Service Bulletin

Subject: CVDF & CVDT Delay Timer Removal

**FOR SERIAL NUMBERS 1120911916 TO 1121073799
AND ALL FAILED DELAY TIMERS**

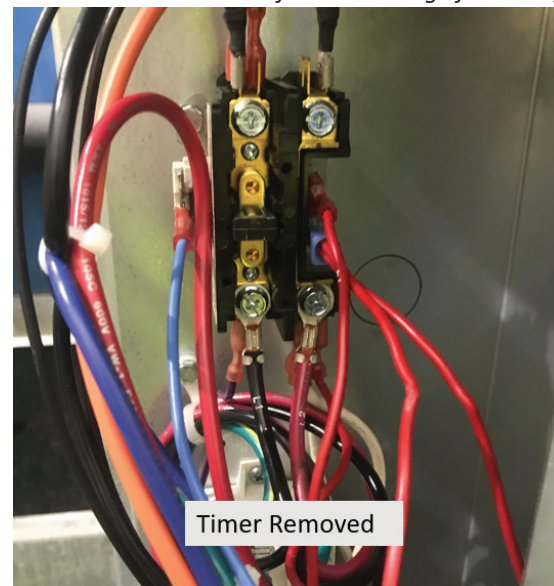
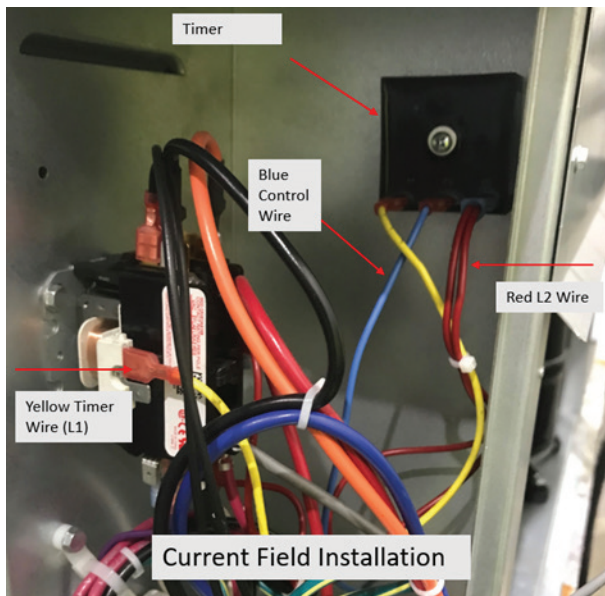
PERMANENT REMOVAL OF DELAY TIMER

NOTE: The delay timer has been discontinued.

1. Order a Delay Timer Removal Kit (Part Number 000018012) for each unit. Once you receive the kit, take the new wiring diagram to place over the existing wiring diagram on the unit.
2. Disconnect power to the condensing unit.
3. Follow lock out tag out procedures.
4. Disconnect blue wire from timer, and place on contactor coil L1, next to the yellow wire.
5. Remove yellow wire from L1 contactor coil and timer.
6. Remove red wires from the timer and place onto the contactor coil L2, next to the other red wire.
7. Remove the timer.
8. Inspect contacts on contactor for any pitting/scoring, replace contactor if pitting/scoring is visible.
9. Re-apply power to condensing unit.
10. Return the delay timer and yellow wire to your local distributor.
11. Complete your Manitowoc Warranty process as normal.

208-230V/60Hz/1Ph or 230V/50Hz/1Ph

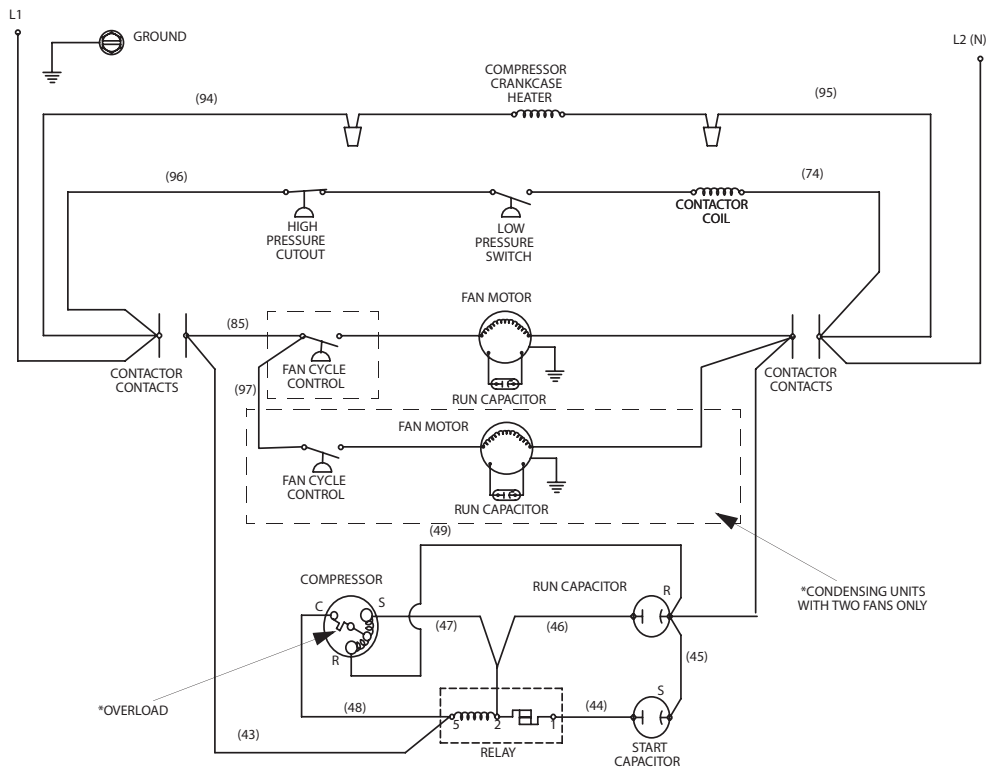
Refer to Next Page for Wiring Diagrams
